MS-16-00507: A Minor Subdivision/Replat of 3101 W. 31st Street: Block One, Lots 1 and 2, Central Bank of the Midwest Subdivision to divide the property into two lots. Submitted by Landplan Engineering for Central Bank of the Midwest, property owner of record.

ADMINISTRATIVE DETERMINATION: The Planning Director approves the above-described Minor Subdivision, subject to the following conditions:

Figure 1: Existing Intersection ROW

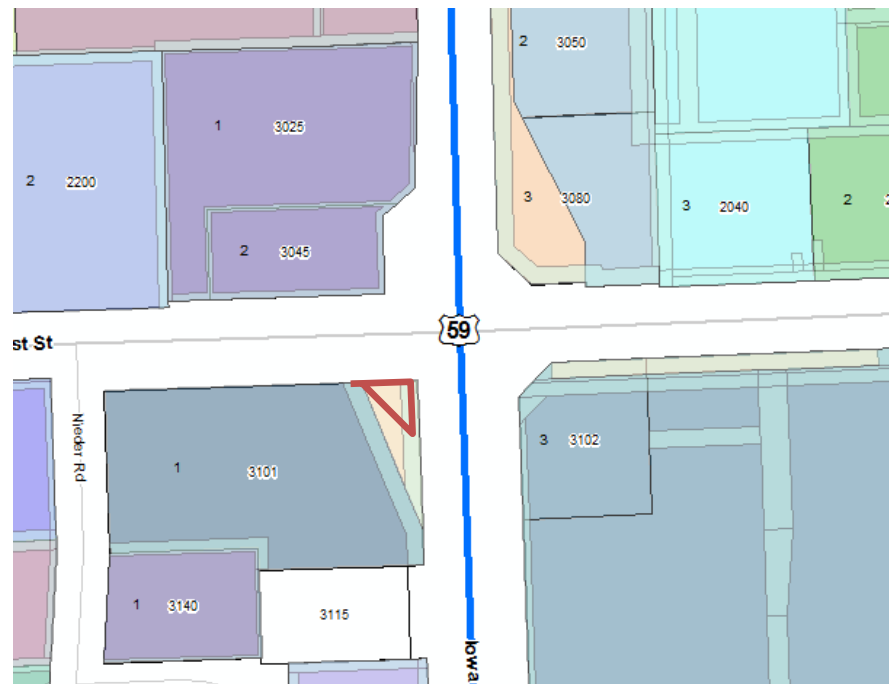
The right-of-way at intersections is typically wider to accommodate those improvements and infrastructure (poles, boxes, transformers) both above and below ground that are required to manage vehicular and pedestrian movements. Three of the four corners of the Iowa Street/31st Street intersection include wider right-of-way as shown in the graphic below. Staff recommends that a like dedication of right-of-way be provided for this Minor Subdivision. The dedication of additional right-of-way for S. Iowa Street will not impact the existing improvements relative to zoning setbacks. The following image highlights the area recommended for ROW dedication.

A variance per section 20-813 (g) is required regarding ROW width and must be approved by the Planning Commission. This meeting is scheduled for 25 January 2017.

1. Submission of a revised master street tree plan as discussed in the body of the staff report.
2. Submission of a revised Minor Subdivision drawing with the following notes and changes:
 - a. Add a note confirming the variance by the Planning Commission for a reduction in right-of-way for W. 31st Street and S. Iowa Street with the date.
 - b. Add signature block for Planning Commission Chair.
 - c. Add a note prohibiting access to Iowa Street/U.S. 59 from Lot 1.
 - d. Revise drawing to show dedication of additional ROW at corner of W. 31st Street and S. Iowa Street to include all existing improvements at the intersection.

Figure 2: W. 31st Street Trees

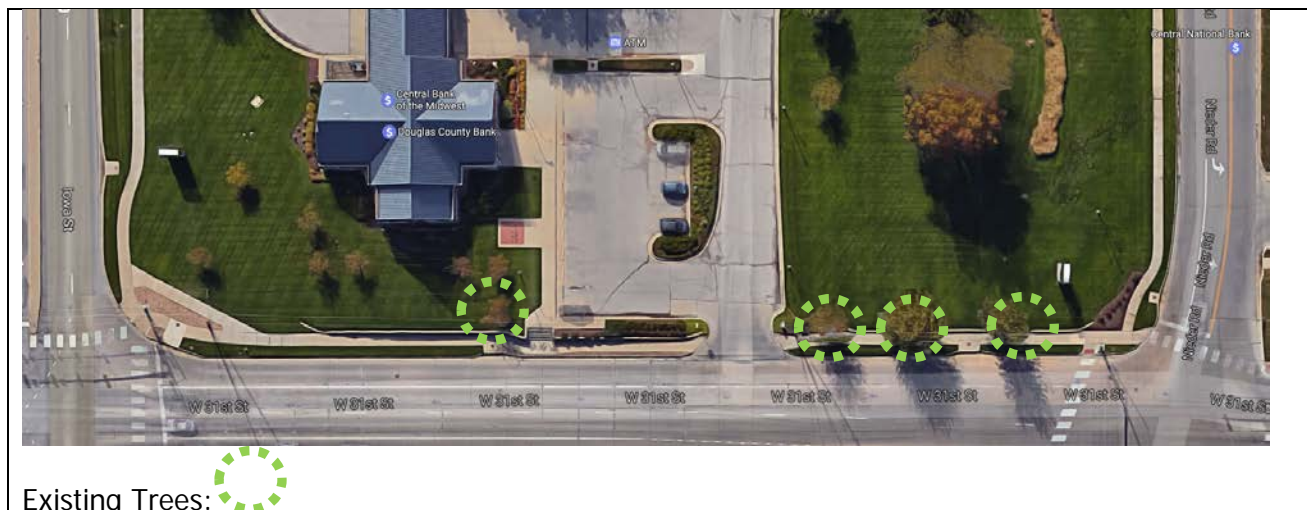
The frontage along W. 31st Street is divided between the two lots. The proposed master street tree plan shows the required number of street trees for the new lot (Lot 2, Block 1). There are three existing trees. Development of the lot will require the installation of one additional tree for Lot 2, Block 1. W. 31st Street frontage for Lot 1, Block 1 is encumbered by overhead and underground utilities as well as sidewalk and pavement. As W. 31st Street has been widened and improved the amount of green space along the north property line has been reduced through the acquisition of right-of-way.

The plan states that there are 6 street trees existing for Lot 1, Block 1. All but one of the street trees is setback more than 40' from the back of the curb.

Staff recommends the Master Street Tree Plan be revised to reflect the number of existing trees that can reasonably be counted toward street trees as follows:

<u>Along Iowa Street</u>	<u>Trees Required</u>	<u>Existing Trees</u>	<u>New Trees to be Provided</u>
Lot 1, Block One	7	1	6
<u>Along 31st Street</u>			
Lot 1, Block One	8	1	7
Lot 2, Block One	4	3	1
<u>Along Nieder Road</u>			
Lot 1, Block One	1	0	0
Lot 2, Block One	5	0	5
